PLAN COMMISSION STAFF REPORT

Agenda Item: PC Docket No. 20-009

Application Type: **DEVELOPMENT PLAN**

Summary: Guy Costanza/GM Contracting requesting approval of a development plan for a commercial development at 407-411 Ridge Road.

SHEET
C-2.0

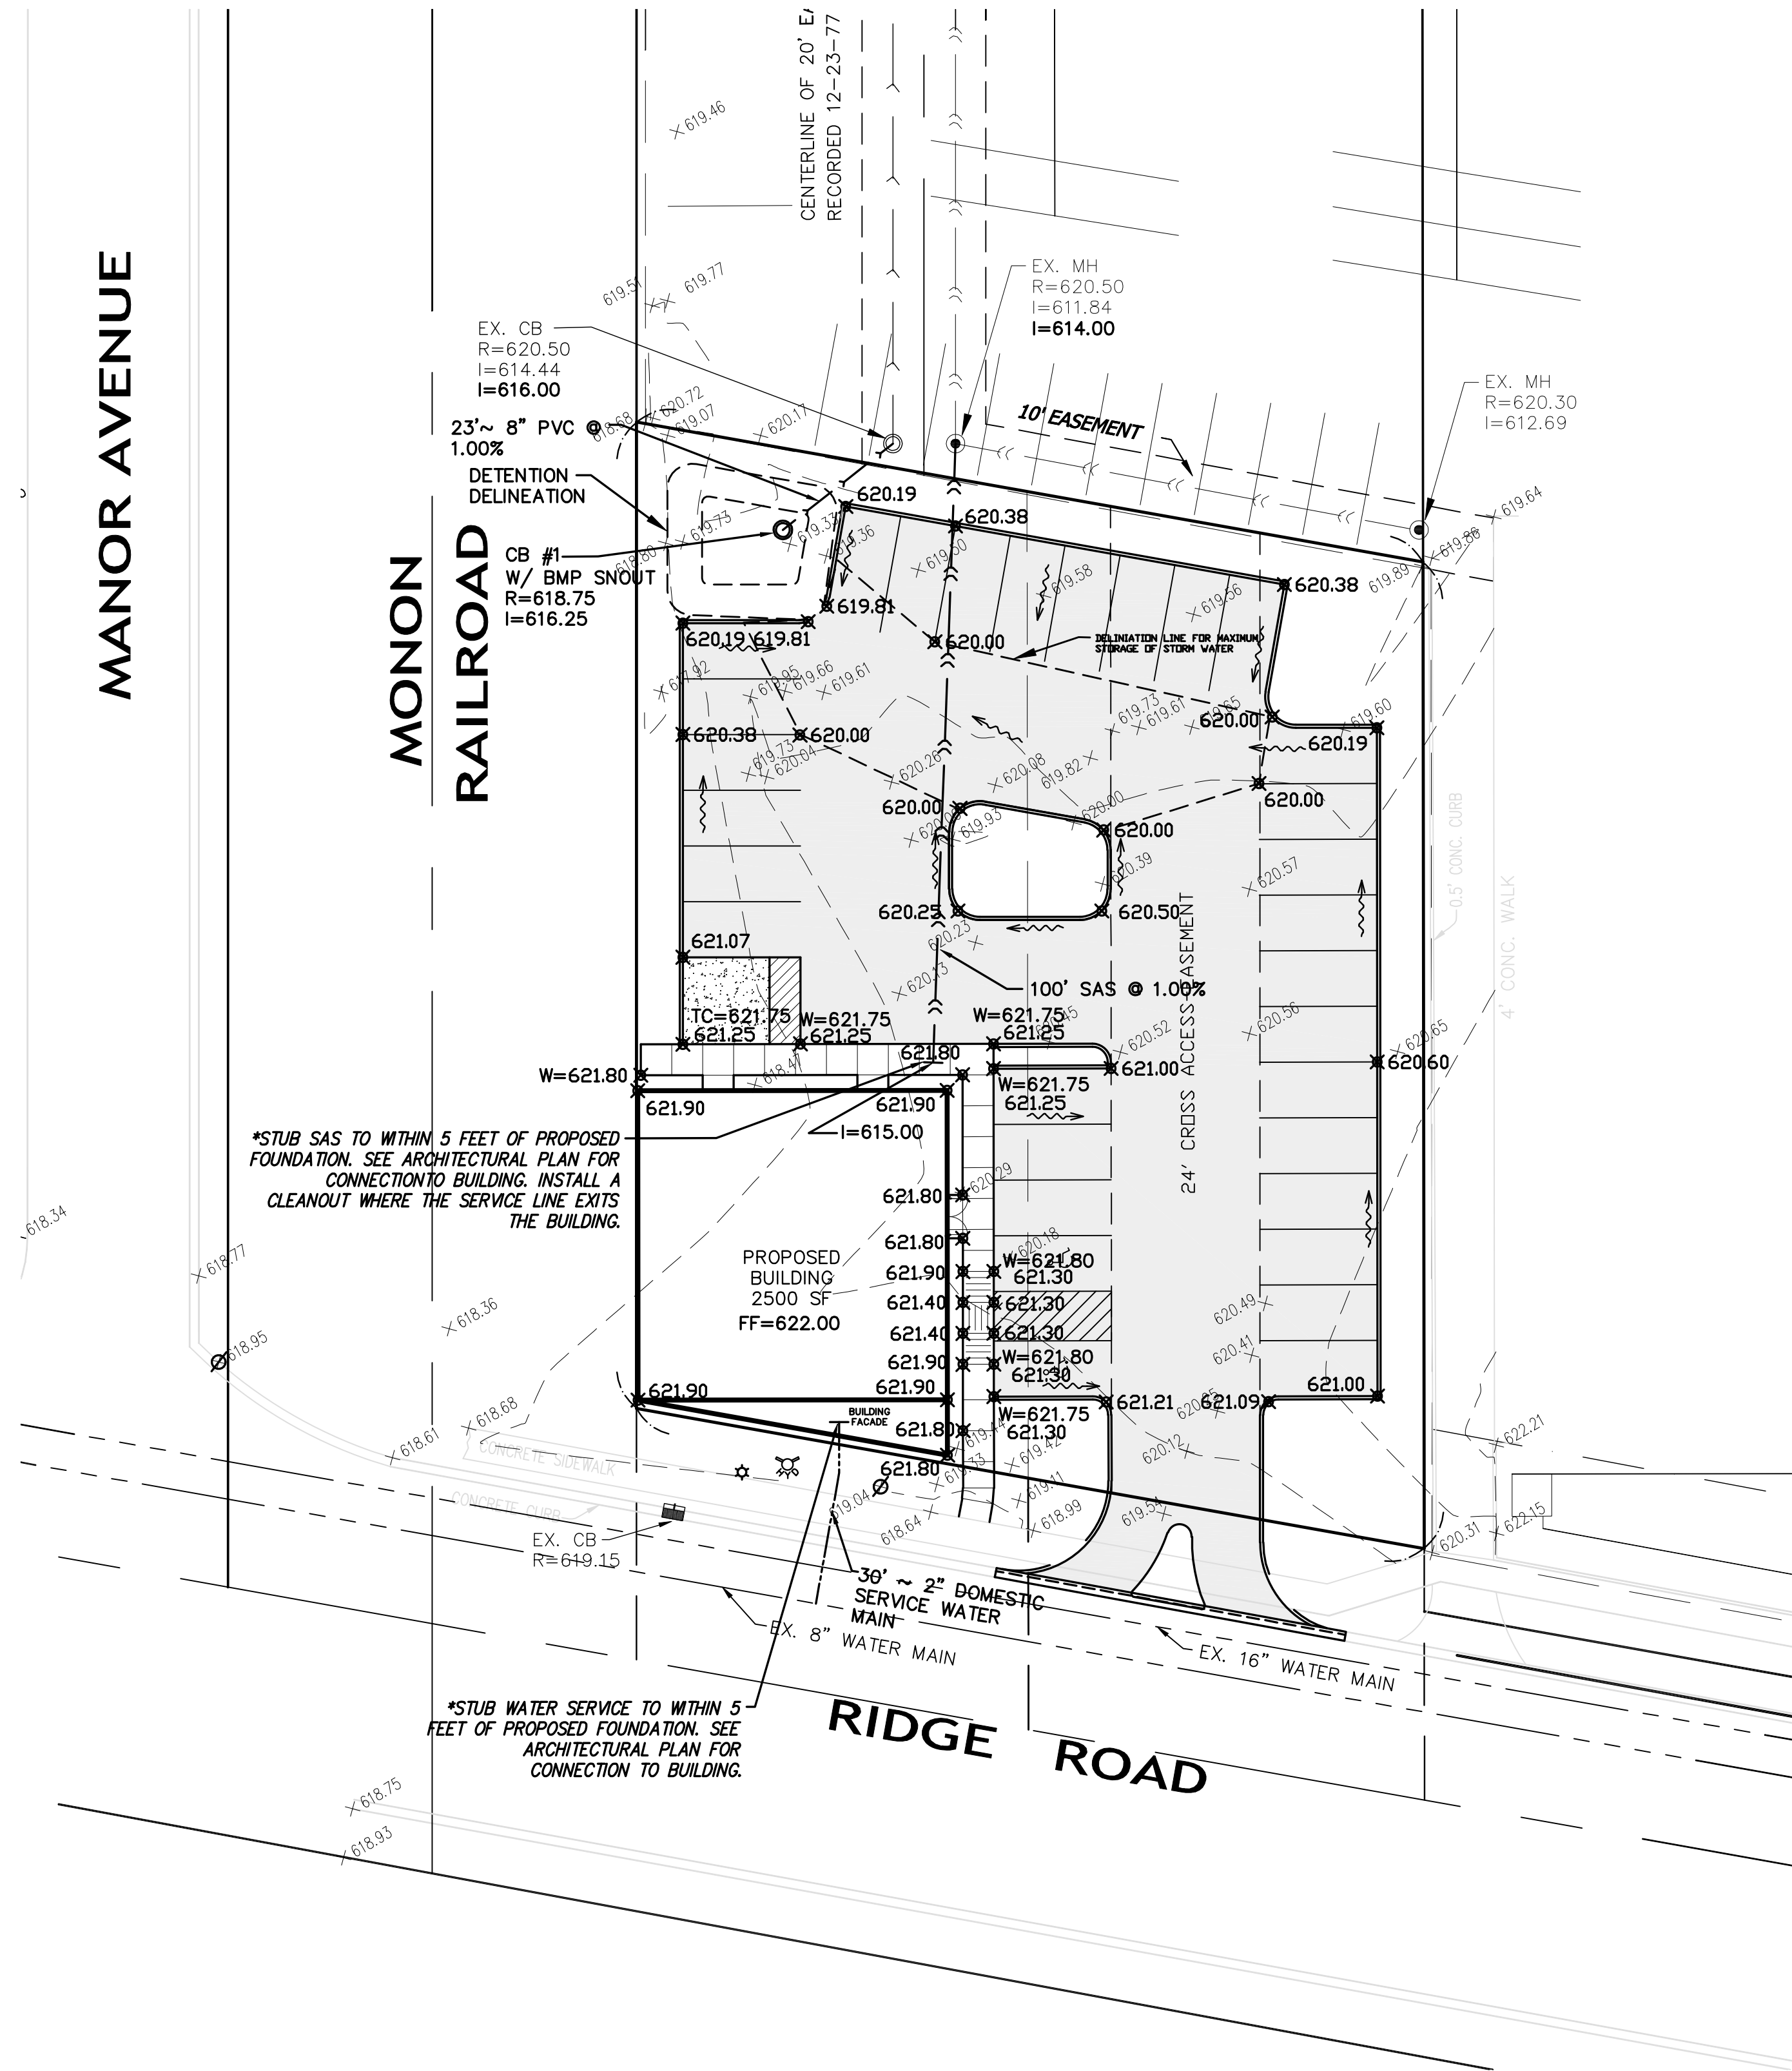
Standard	Requirement	Proposed	Compliant
Front setback	0'-15'	0'	Y
Side setback	0'-24'	77'	N
Rear setback minimum	3'	Approx. 98'	Y
Frontage buildout	80%	Approx. 39%	N
Entrances	Front Façade	East side of building	N
Location of building	Parallel to ROW	Parallel to ROW	Y
Off-Street parking location	3rd lot layer only	2nd lot layer	N
Off-Street parking surface	Asphalt, concrete or other hard surface	Asphalt	Y
Driveway/vehicular entrance width maximum	24'	24'	Y
Trash receptacle/Dumpster	Enclosure constructed of same building materials as building	Enclosure - no detail	Unknown
Loading, Storage, Utility Box & Service Meter	3rd lot layer only	Unknown	Unknown
HVAC Equipment, Utility, Service and Mechanical Equipment	3rd lot layer only or 2nd lot layer if screened	Unknown	Unknown
Street screen location	Coplanar with façade	Coplanar with façade	Y
Parking, Loading Areas, Service Areas, Outdoor Storage, Drive-Throughs, Trash Receptacles/ Dumpsters, HVAC and other equipment Screened from Frontage, Civic Space and Adjacent Property	Various screens	Various	Y/N

Standard	Requirement	Proposed	Compliant
Parking screen	3'-3.5' coplanar with façade	3'-3.5' coplanar with façade	Y
Landscape Islands	Interior rows terminated in islands	1 substandard island	N
Landscape Islands	1 island / 10 spaces: 3 required	4 provided	Y
Landscape Islands Design	Equal to parking spaces	3 equal, 1 substandard	N
Landscape Islands Design	1 shade tree per island	3 compliant / 1 not	N
Buffer	5' landscape buffer adjacent to alley	7.7' buffer	Y
Trees	1 per 2000 sf of parking area	Unknown	Unknown
Trees	All parking spaces within 72' of a tree	Unknown	Unknown

1. Detention provided through parking storage and/or underground storage rather than a traditional detention pond.
2. Receive approval of plans from the Munster Town Engineer.
3. Update the information shown on the site plan, the landscaping plan, and the photometric plan to reflect the revised site plans and the standards of the zoning ordinance.
4. Verify that landscaped areas are sufficient to accommodate the required tree replacement or, if planting on another site in town, provide documentation of the plans.
5. Include required streetscape improvements: planter strip or planter well, thoroughfare trees.
